Access Compliance Report

Public Rights-of-Way

Intersection ID: 11841	Main Street: E_18TH_ST	Cross Street: HARRILL_ST	Location: E
ADA ID: 93776AB481A2	Ramp Type: Directional1	Initial Pass/Fail: Pass	Overall Compliance: No
Severity Score: 0			
Codes/Mitigation Info/Possible Solution		Field Measurements/Component Compliance

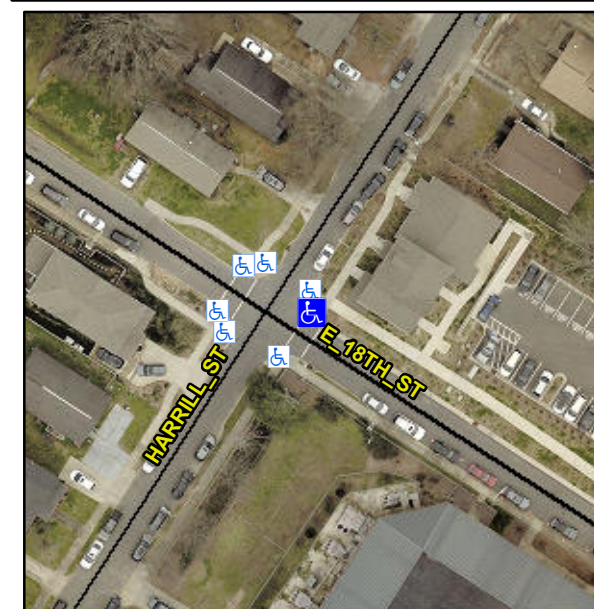
Not Found, R304.5.3, R302.7

Compliance	Description	Data	Compliance	Description	Data
N/A	Ramp Length (in)	74.0	Yes	Grade Break?	Yes
Yes	Ramp Width (in)	59.0	No	Grade Break Slope (%)	5.9
Yes	Ramp Slope (%)	5.4	Yes	Grade Break XSlope (%)	1.7
Yes	Ramp XSlope (%)	1.6			
Yes	Flare Type LT	N/A	Yes	Flare Type RT	N/A
N/A	Flare Slope LT (%)	N/A	N/A	Flare Slope RT (%)	N/A
N/A	Flare Traversable LT?	No	N/A	Flare Traversable RT?	No
Yes	Landing Length (in)	59.0	Yes	DWS Provided?	Yes
Yes	Landing Width (in)	59.0	Yes	DWS Contrast?	Yes
Yes	Landing Slope (%)	1.2	Yes	DWS Length (in)	24.0
Yes	Landing X Slope (%)	1.9	Yes	DWS Full Width?	Yes
N/A	Landing Curb? (Y/N)	N/A	Yes	DWS Offset LT (in)	1.0
N/A	Shared Landing?	Yes	Yes	DWS Offset RT (in)	22.5
No	Gutter Ponding?	Yes	Yes	Gutter Slope (%)	0.4
Yes	Gutter Lip Ht (in)	0.0	Yes	Gutter X Slope (%)	2.0
N/A	Painted X Walk1?	No		Road Slope (%)	2.0
	X Walk 1 Direction	To SW		Road X Slope (%)	0.4
	X Walk 1 Width (in)	N/A		Clear Space?	Yes

Remove & Replace Entire Ramp.
